TM 11-6625-274-35

TEST SETS, ELECTRON TUBE TV-7/U,
TV-7A/U, TV-7B/U, AND TV-7D/U

CHANGE }
No. 5 }

**Direct Support, General Support, and Depot Maintenance Manual
TEST SETS, ELECTRON TUBE TV-7/U,
TV-7A/U, TV-7B/U, AND TV-7D/U**

Figure 44(2). Test Set, Electron Tub TV-7D, schematic diagram (sheet 2).

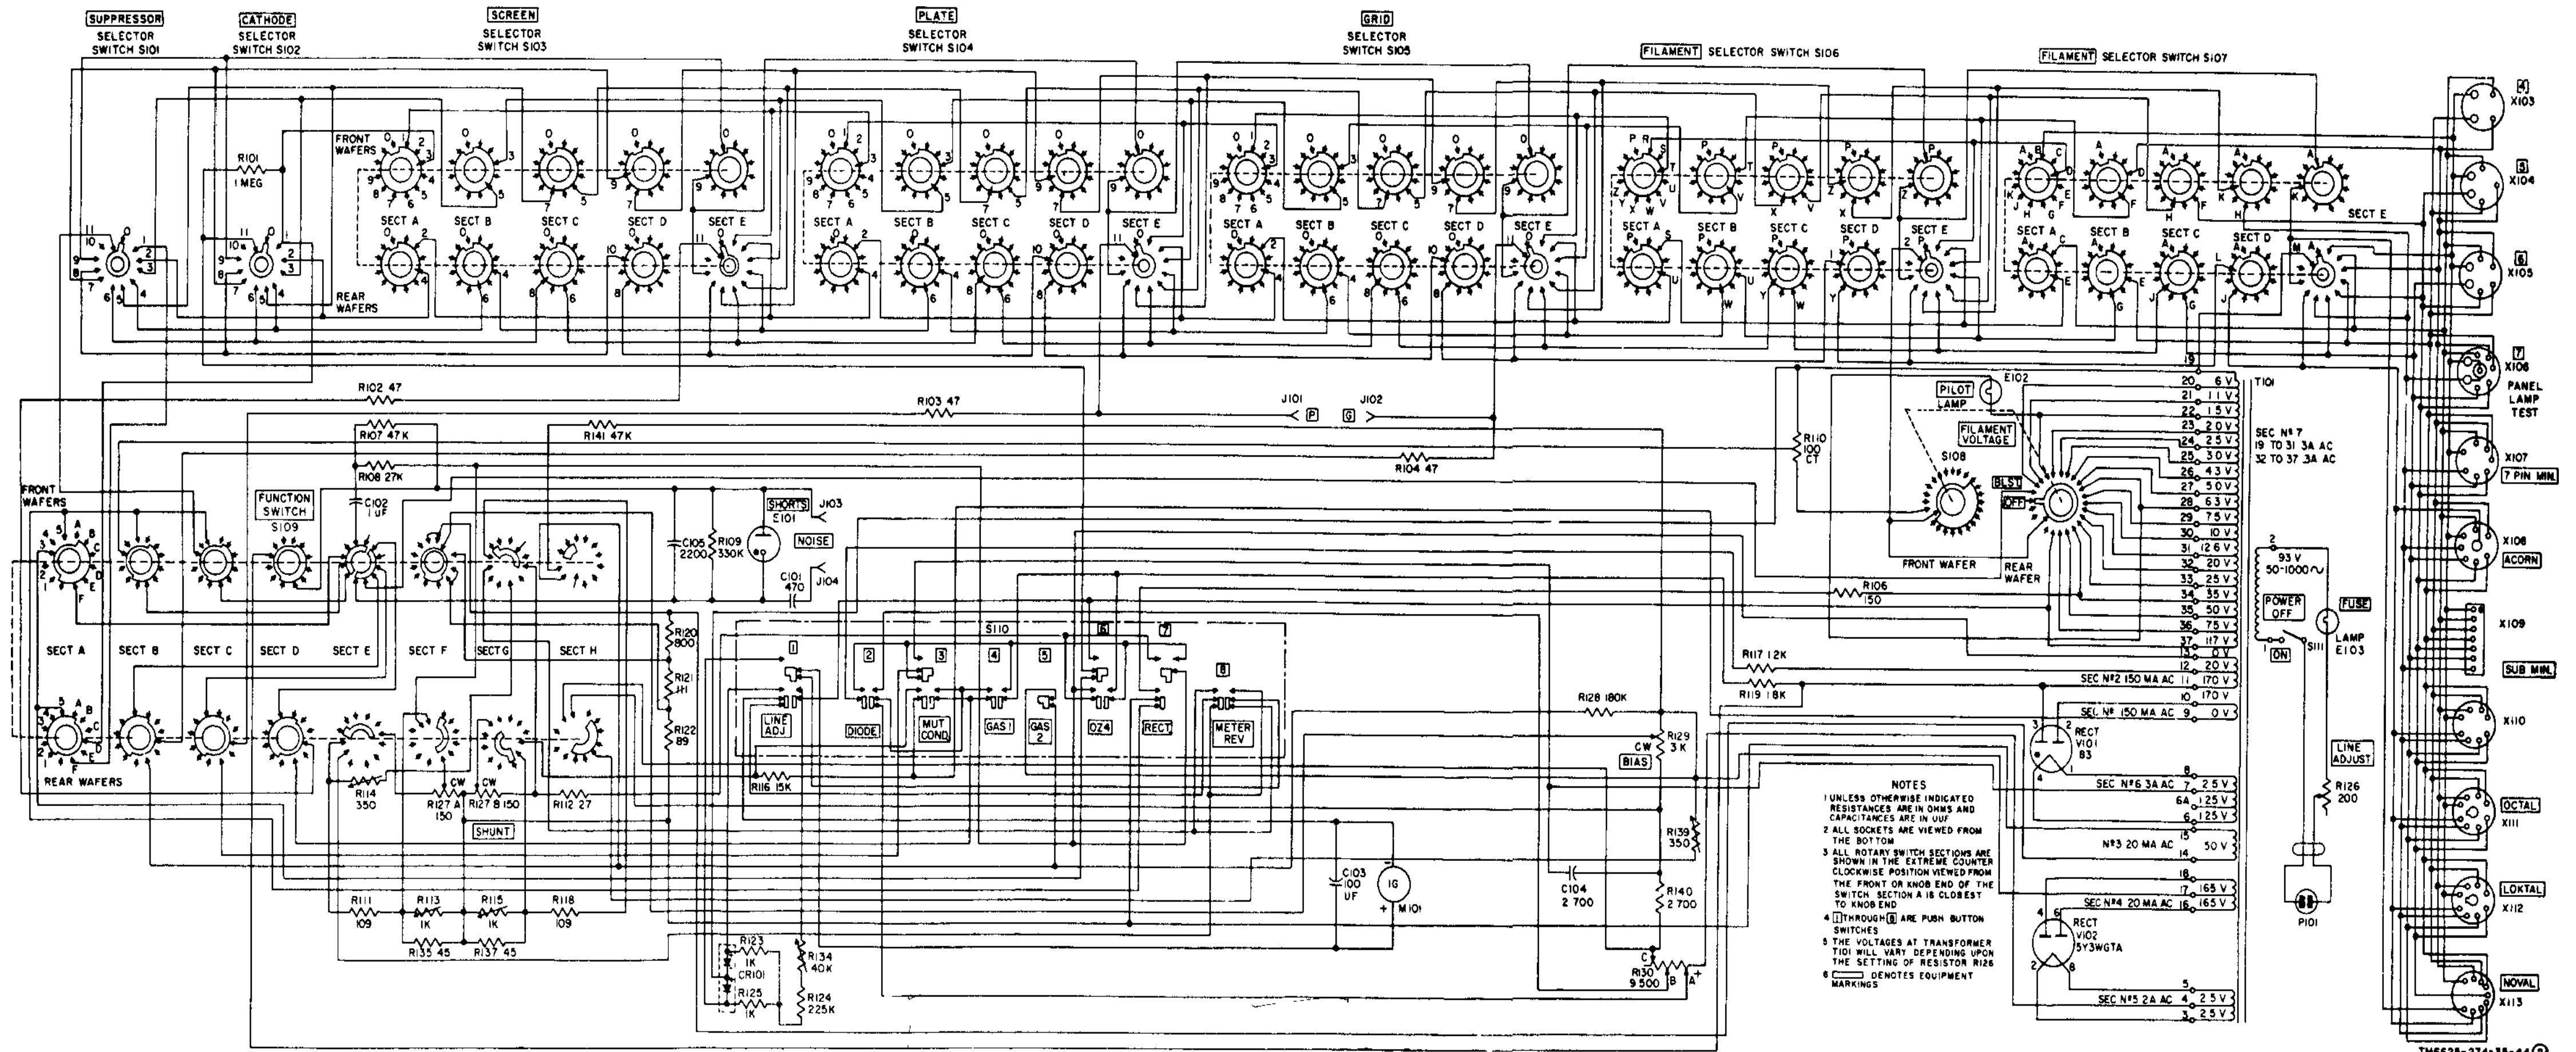
Figure 44② (sheet 2), switch S109, section F. Delete the connection between contacts D and E and substitute 2 connections between C and E.
